Access Compliance Report

Public Rights-of-Way

(Curb Ramps)

Intersection ID: 17746	Main Street: BARWICK_RD	Cross Street: MERWICK_CR	Location: E
ADA ID: 915862F8B6F8	Ramp Type: PerpDiag	Initial Pass/Fail: Fail	Overall Compliance: No
Severity Score: 8.75			
Codes/Mitigation Info/Possible Solution		Field Measurements/Component Compliance

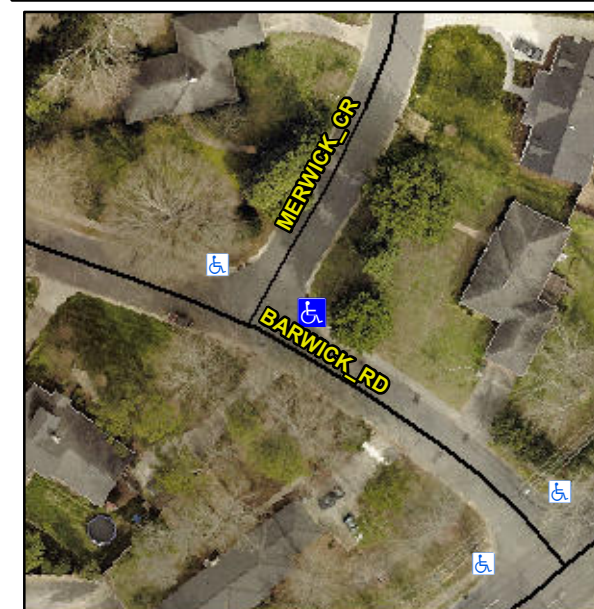
Not Found, R304.5.1

Compliance	Description	Data	Compliance	Description	Data
N/A	Ramp Length (in)	48.0	Yes	Ramp Slope (%)	7.4
No	Ramp Width (in)	43.0	Yes	Ramp XSlope (%)	0.7
N/A	Flare Type LT	N/A	N/A	Flare Type RT	N/A
N/A	Flare Slope LT (%)	N/A	N/A	Flare Slope RT (%)	N/A
N/A	Flare Traversable LT?	N/A	N/A	Flare Traversable RT?	N/A
N/A	Landing Length (in)	N/A	N/A	DWS Provided?	N/A
N/A	Landing Width (in)	N/A	N/A	DWS Contrast?	N/A
N/A	Landing Slope (%)	N/A	N/A	DWS Length (in)	N/A
N/A	Landing X Slope (%)	N/A	N/A	DWS Full Width?	N/A
N/A	Landing Curb? (Y/N)	N/A	N/A	DWS Offset (in)	N/A
N/A	Shared Landing?	N/A			
N/A	Gutter Ponding?	N/A	N/A	Gutter Slope (%)	N/A
N/A	Gutter Lip Ht (in)	N/A	N/A	Gutter X Slope (%)	N/A
N/A	Painted X Walk1?	No	N/A	Painted X Walk2?	No
	X Walk 1 Direction	To NW		X Walk 2 Direction	To SW
N/A	X Walk 1 Width (in)	N/A	N/A	X Walk 2 Width (in)	N/A
	X Walk 1 Slope (%)	4.0		X Walk 2 Slope (%)	7.0
	X Walk 1 X Slope (%)	4.9		X Walk 2 X Slope (%)	0.9

Remove & Replace Curb Ramp With Two New Directional Ramps or Equivalent.
